QUAD CITIES NUCLEAR POWER STATION UNIT 1

AMENDMENT TO FACILITY OPERATING LICENSE

Amendment No. 61
License No. DPR-29

ATTACHMENT TO LICENSE AMENDMENT NO. 61

FIGURE 3.5-1
(Sheet 1 of 6)

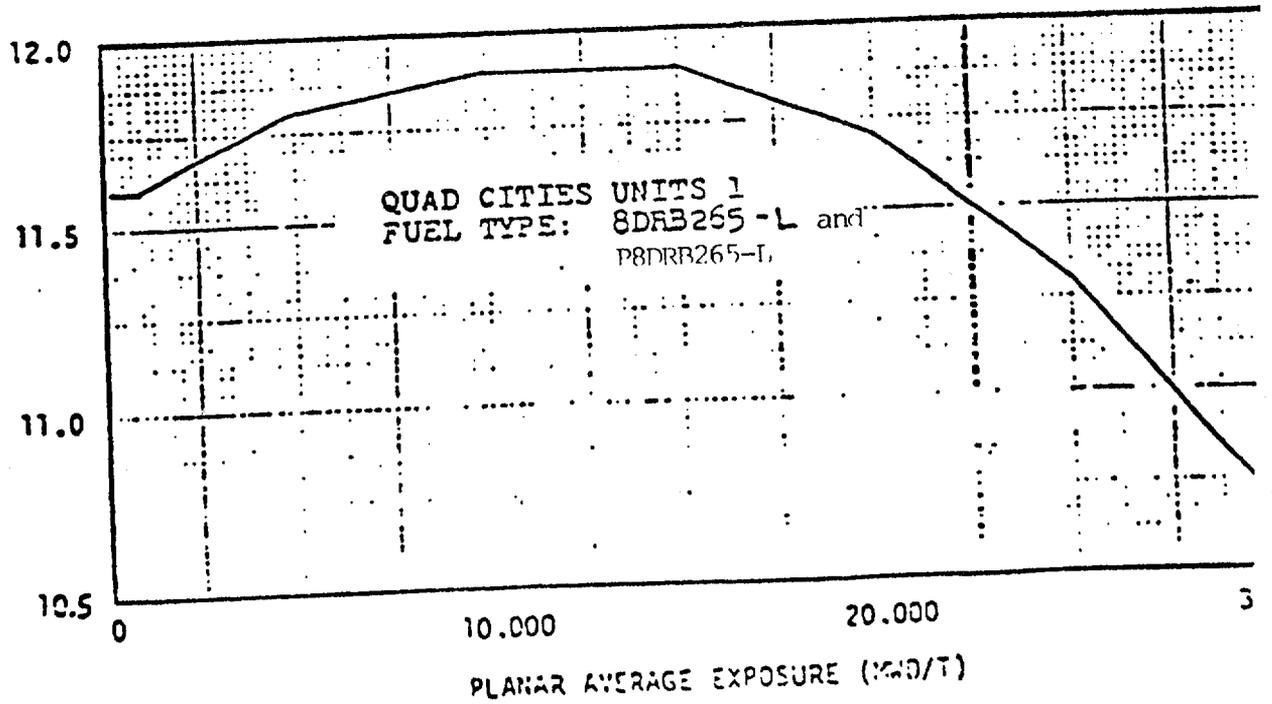
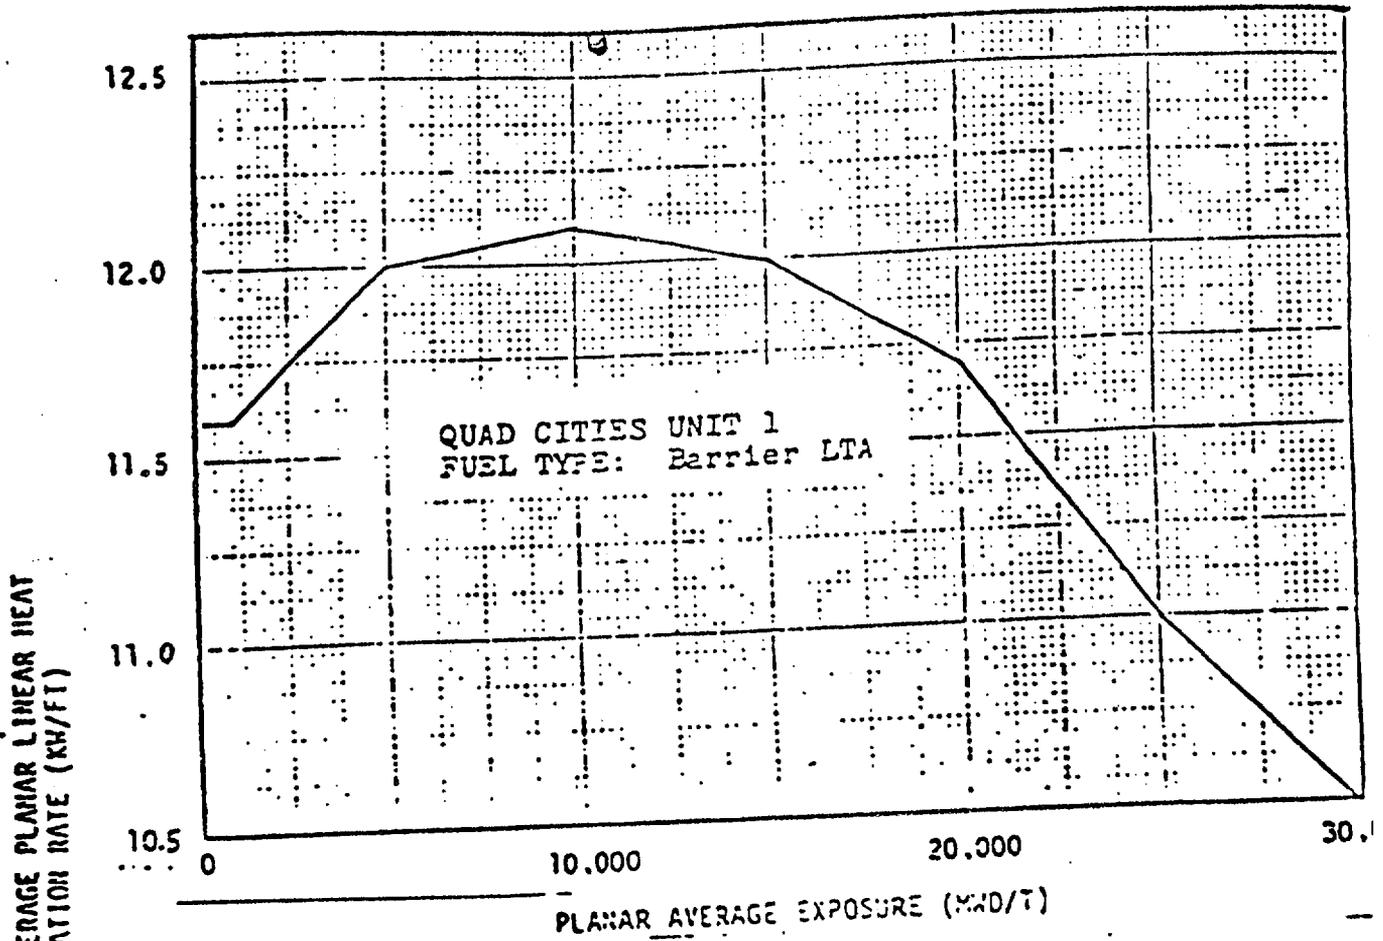
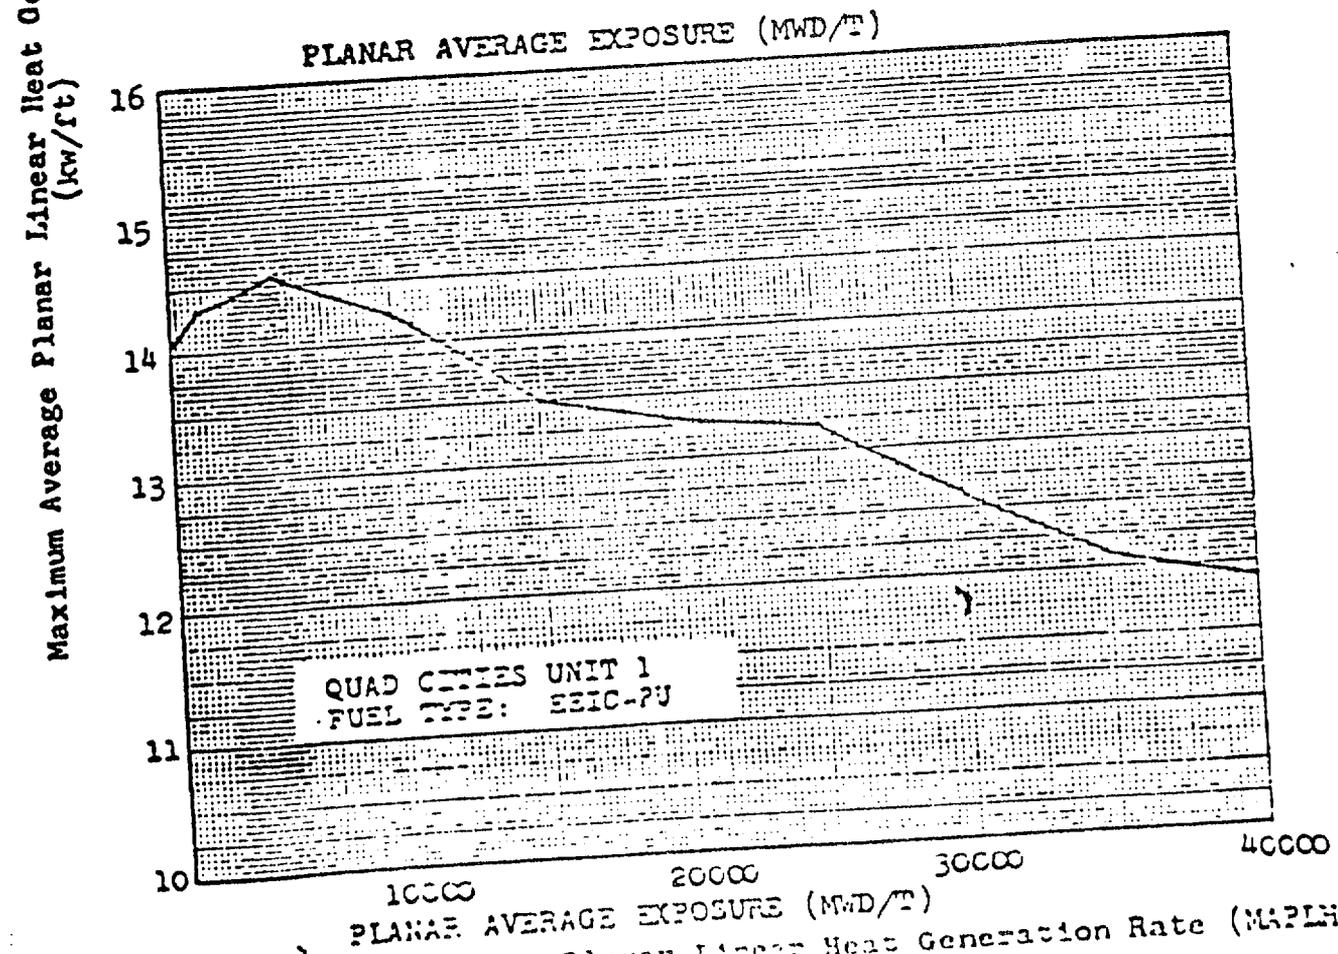
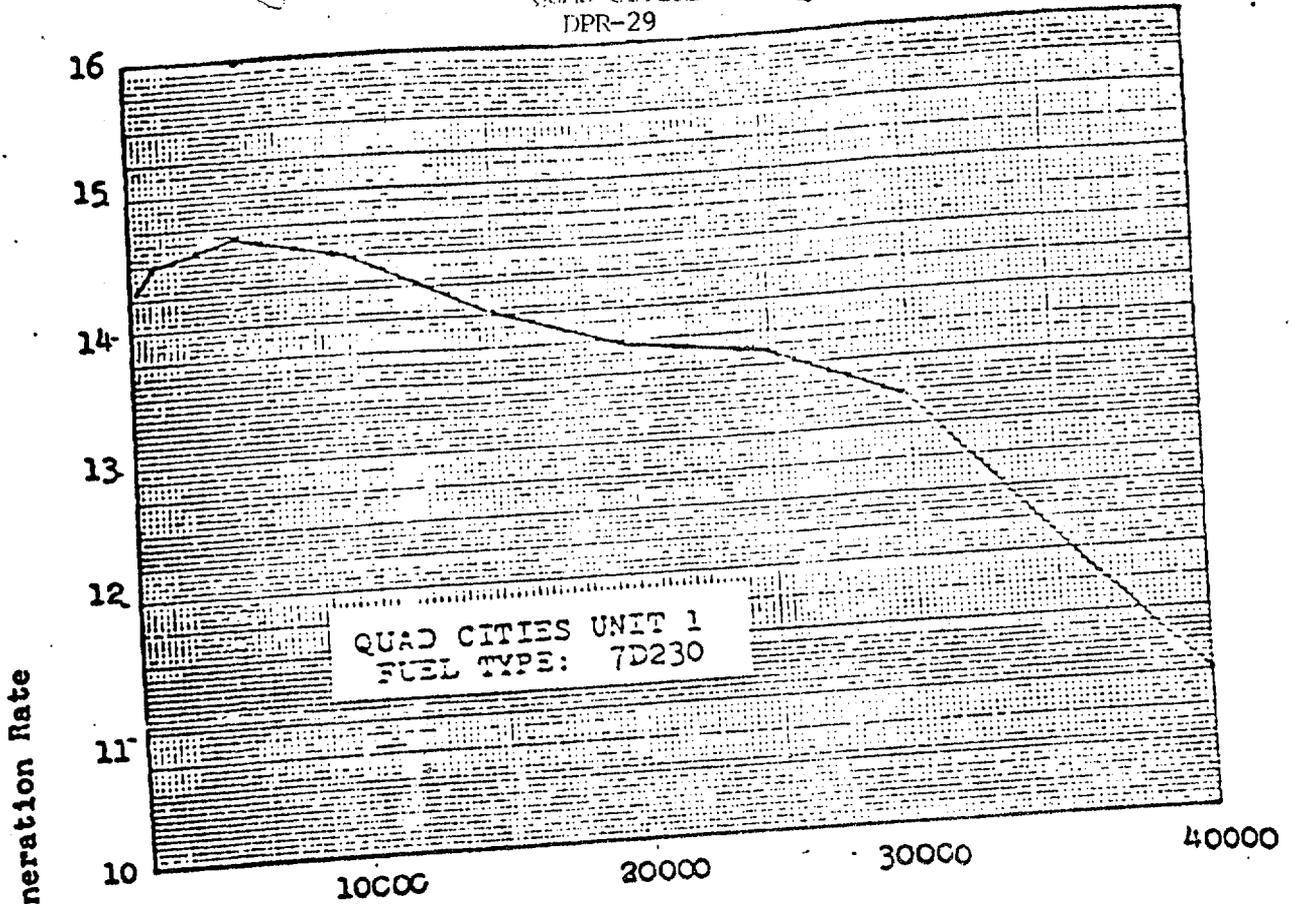
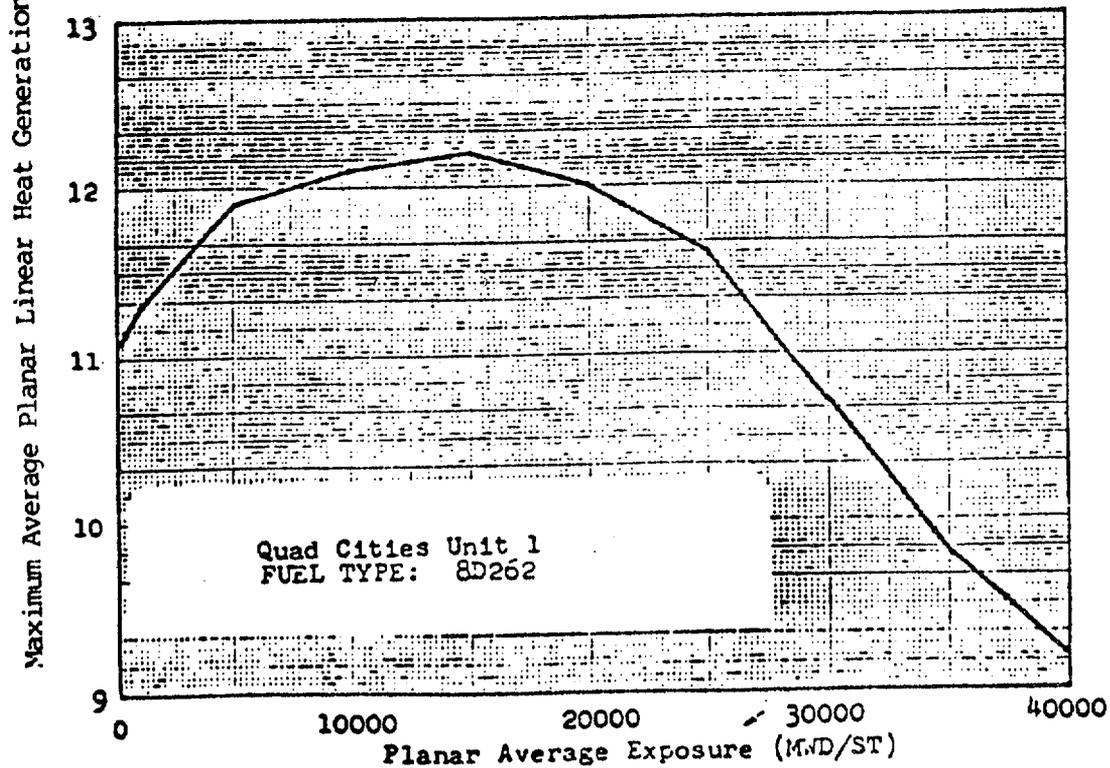
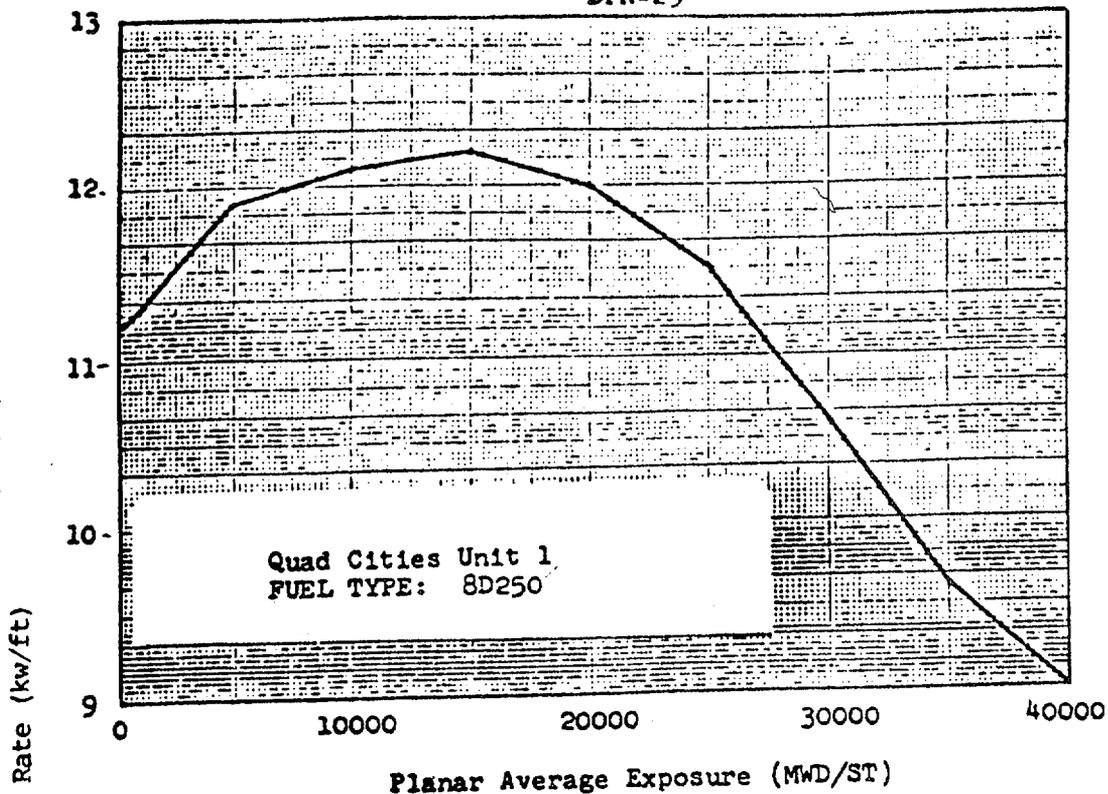
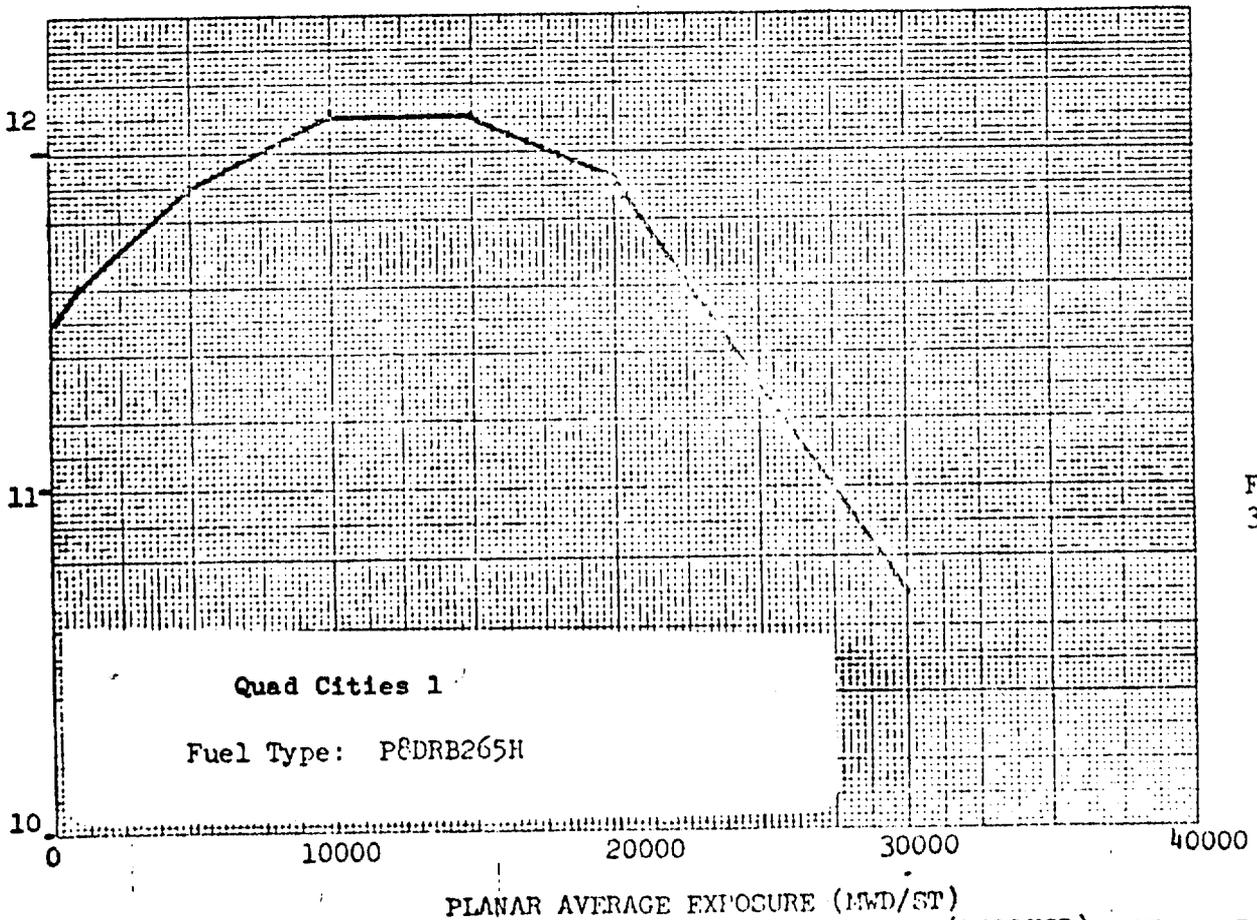
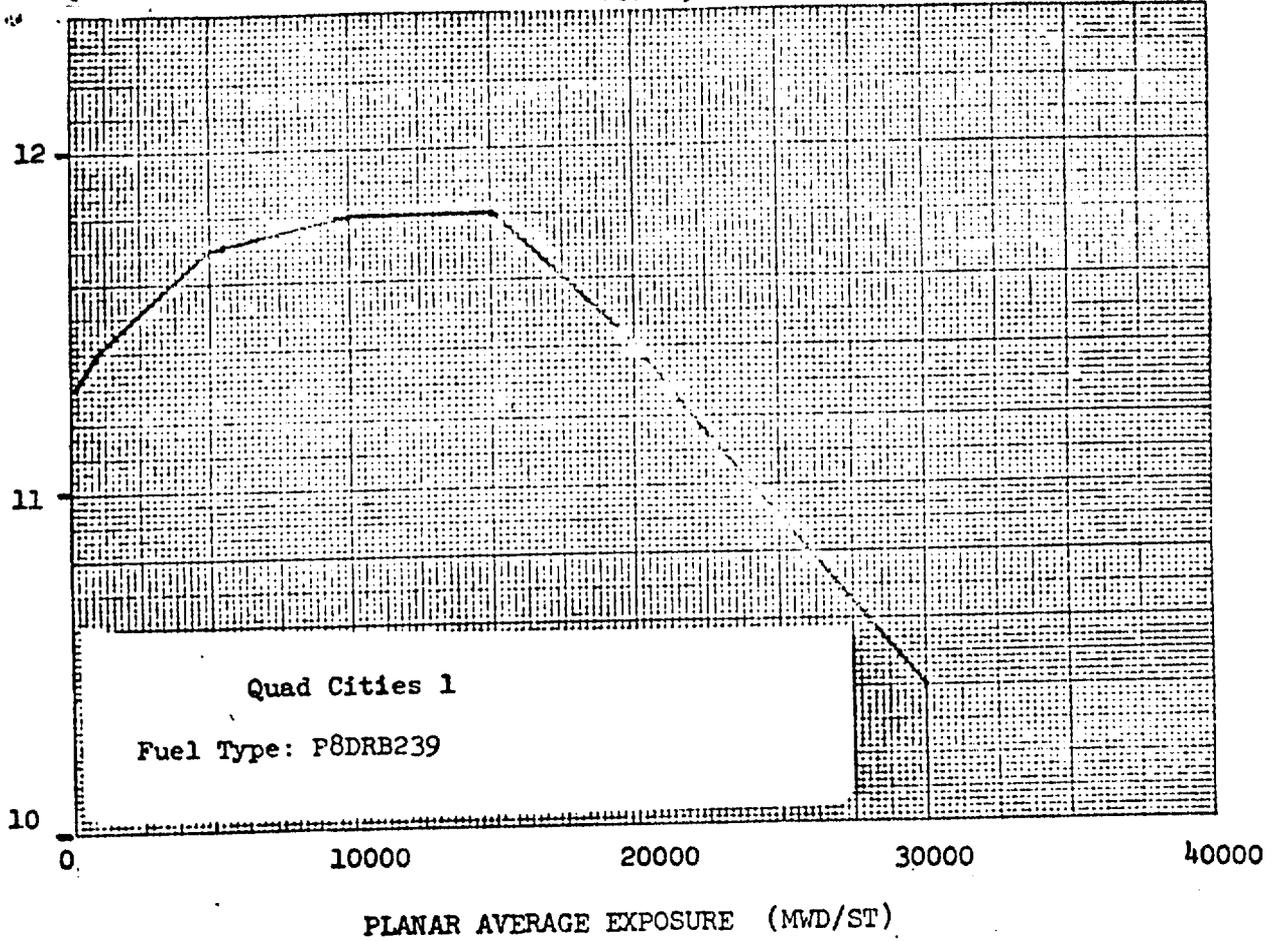
2. Page 1.1/2.1-2a is added.
3. Figure 2.1-2 is deleted.
4. Figure 3.5-1 is being replaced by 6 pages.

Maximum Average Planar Linear Heat Generation Rate (MAPLHGR)
